**FILE:** CSSTP-0007-00(217) Walton/Newton  
P. I. No.: 0007217  
Social Circle Bypass

**SUBJECT: IMPLEMENTATION OF VALUE ENGINEERING STUDY ALTERNATIVES**

Social Circle Bypass  
SR 11 to E. Hightower Trail

SUBJECT: **Value Engineering Study Responses**

\* Culvert #1  
triple 8x7

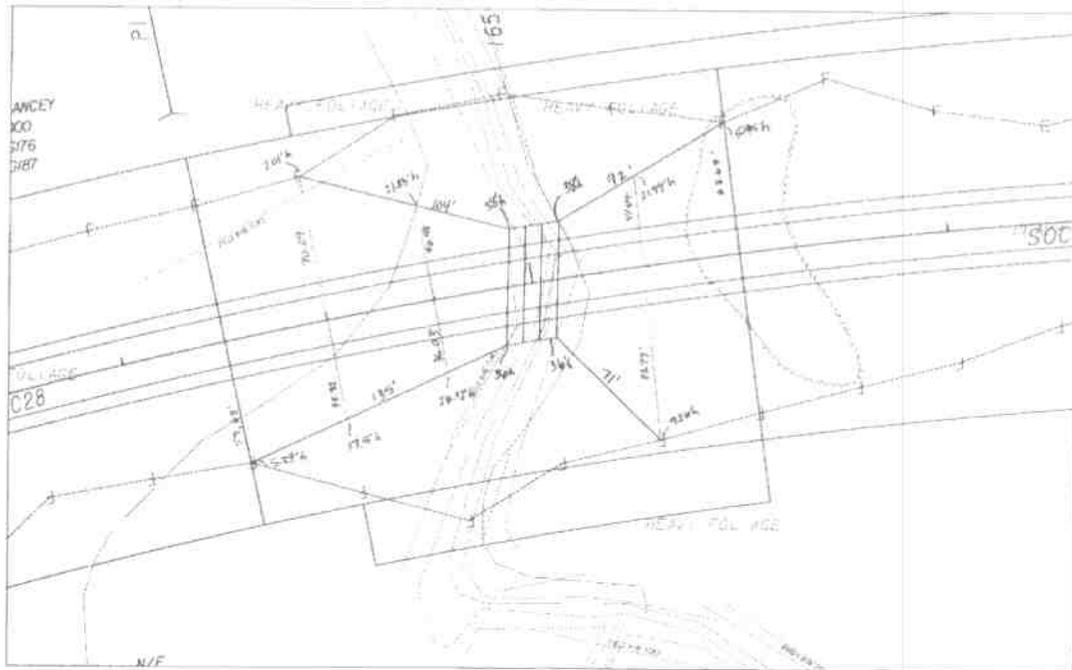
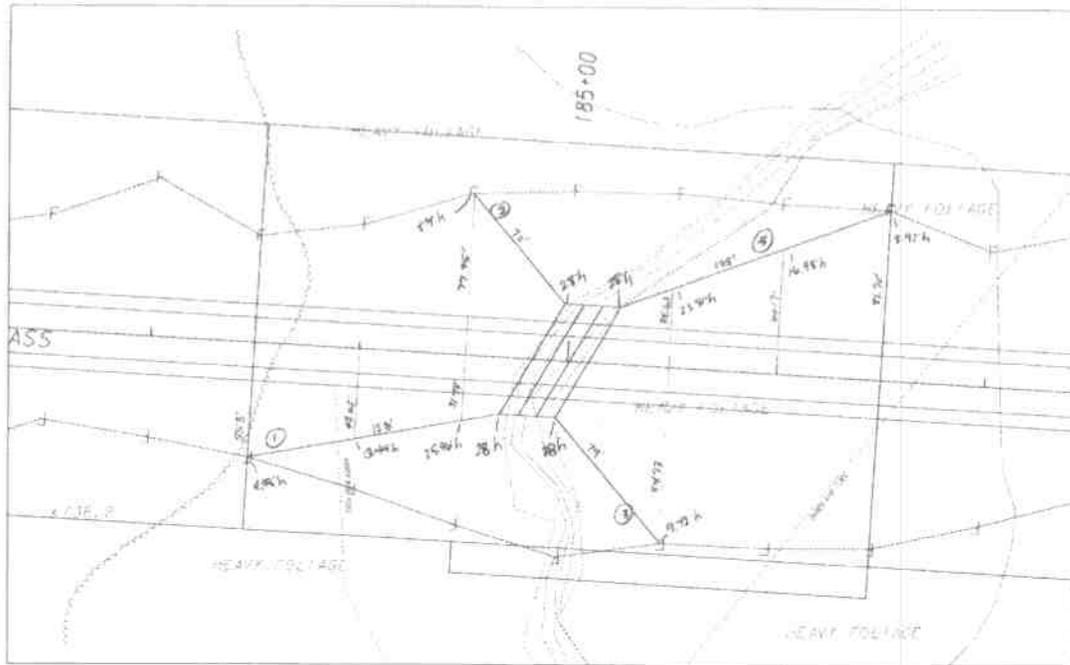
- The original culvert cost including the wing walls was \$1.95 Million. Using the cost developed in the VE study for the CONSPAN culvert (\$700,000) and the total length of culvert (340 feet) the culvert cost is \$2,060/ LF. The original culvert length that was possible was only 60 feet at each location to fit the stream curvature. The actual cost to use the CONSPAN culverts and MSE wing walls is as follows:

- Much of this cost is to construct the MSE walls at fill heights of 20 to 25 feet. These costs are on the order of \$871,000 according to the original culvert estimate. This cost does not include the right of way costs that were originally included in the culvert estimates of approximately \$52,000 and is purely the construction costs. By comparison, the estimated VE bridge cost at \$1,712,700 is \$350,000 less than the revised CONSPAN cost.
- The recommendation *is to use bridges at these locations.*

**Bridge #1** (KC 111- original profile revised slightly)  
 ~sta 165+00

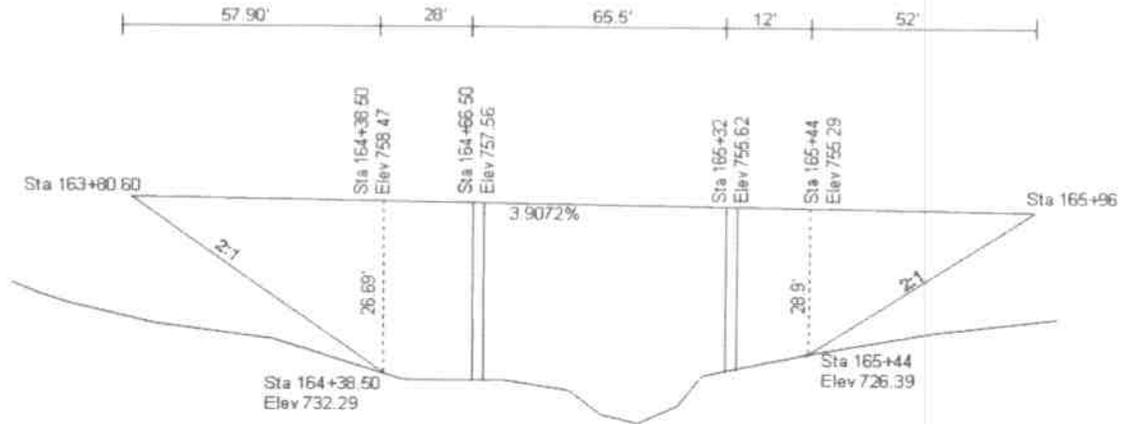
- RS&H has closely examined realigning the profile to reduce the overall volume of earthwork. Through our profile optimization we have been able to save approximately \$582,000 in earthwork cost.
- A portion of the savings would be reduced from the required additional length of bridges associated with the revised profile. The revised bridge cost estimates are \$898,000 for bridge one and \$1,065,300 for bridge two. The original cost estimates were \$966,900 for bridge one and \$965,000 for bridge two.
- The overall cost savings for implementing this alternative is approximately \$412,800.

<b>Bridge cost:</b>	<b>\$95 /sf</b>
<b>Bridge length:</b>	<b>215.4 ft</b>
<b>Bridge Width*:</b>	<b>47.25 ft</b>
<b>Total cost =</b>	<b>\$966,876.75</b>
<b>original bridge cost estimate=</b>	<b>\$898,000.00</b>
<b>cost difference=</b>	<b>\$68,876.75</b>
